Planning Approval Environmental Review Form

Assessment Name:	High Street Steps rectification
Prepared by:	Sydney Metro
Prepared for:	Sydney Metro and Besix Watpac – Barangaroo Station contractor
Assessment number	TfNSW 76
Type of assessment:	Assessment under EP&A Act 1979, Division 5.2
Version:	Final 2.0
Planning approval No. (where relevant):	SSI_7400
Date required:	7 September 2023
iCentral number	SM-23-00854648

SUBJECT: Advice for repairs to High St Steps landing, Hickson Road Retaining Wall and cutting, Barangaroo

Figure 1: Illustration showing the uneven edge and trip hazard once the Hickson Road footpath is reinstated.

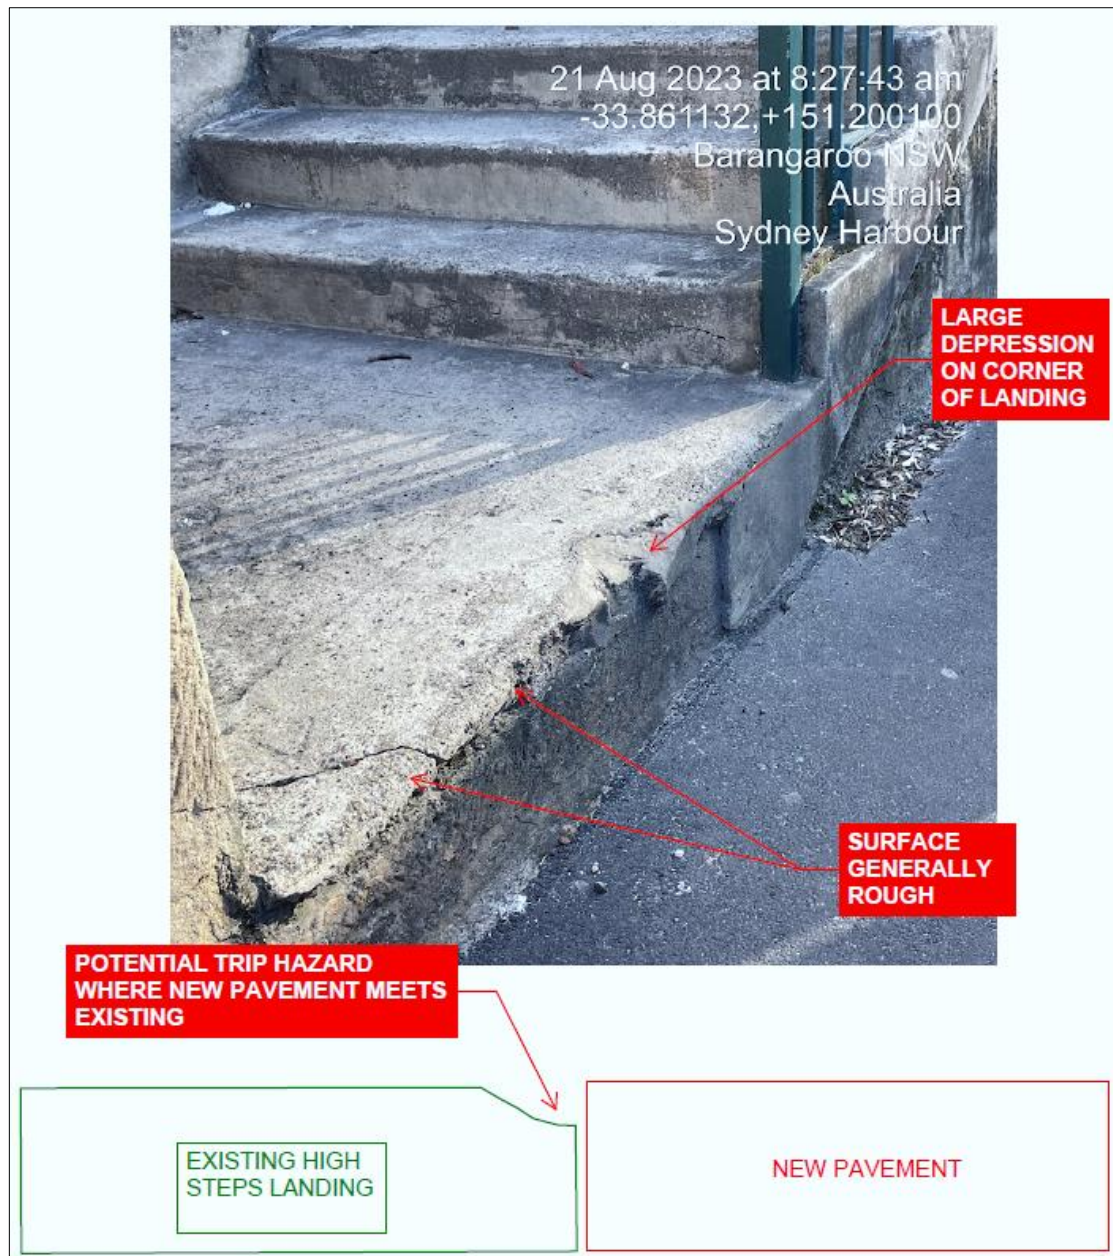
The landing of the High Street steps is in need of repair. The cement render surface is cracked, has rough edges, and old repairs are failing, causing an uneven edge. Reinstatement of the Hickson Road footpath by the project requires the new footpath surface to be flush with the High Street steps landing. The uneven edge will be a trips and falls risk once the footpath is reinstated. Repairs are proposed to the landing surface to eliminate those risks (Figure 1).

Damage to the original sandstone cut should be avoided. Surface repairs should be limited to the removal and replacement of the areas of damaged concrete and underlying cement mortar, and the intrusive repairs only.

Figure 3: Detail showing the layers of construction within the landing surface.

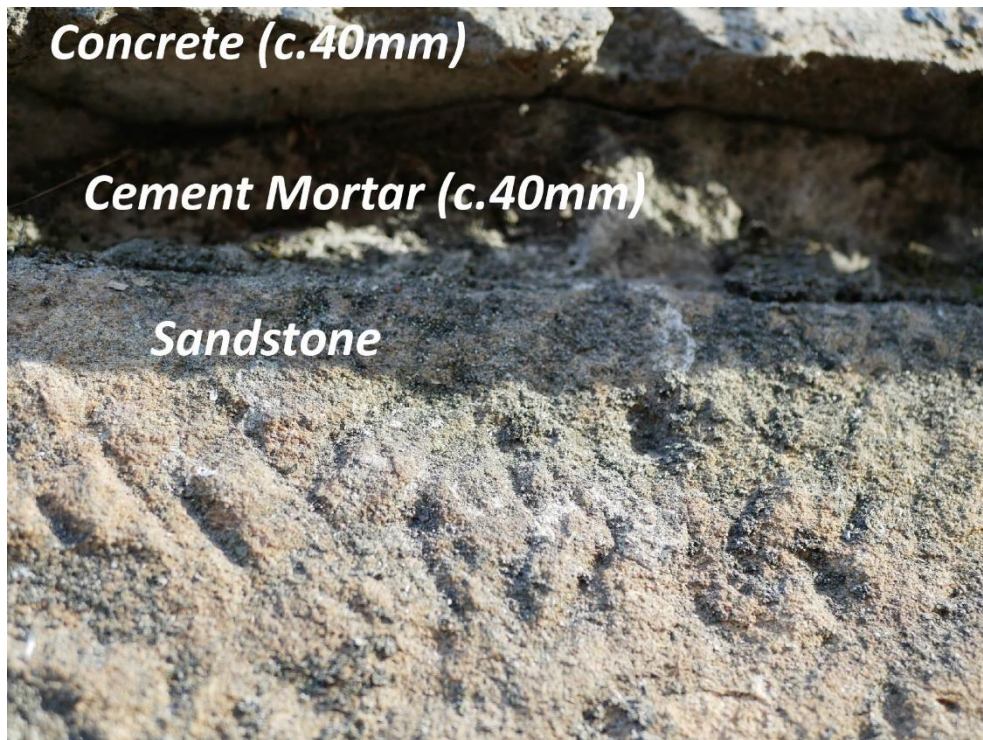
The landing recess has been cut from the outcropping sandstone which forms the lower part of the wall and cutting in this area. The area of the landing has been cut 80-85mm lower than the existing surface and then finished with concrete. There appears to be a layer of fine and brittle cement mortar (c.40mm) between the sandstone and the concrete. This was only visible where the lip of the landing had broken away (Figure 3). The concrete finish contains a dense gravel aggregate (Figure 2). The steps and landing are all finished with the same mix, although there are twentieth-century repairs throughout that have not been matched correctly. The Hickson Road face of the landing step was originally cement rendered, but this has mostly broken away (Figure 4). The remaining render on the face has no aggregate and appears to be part of a later repair.
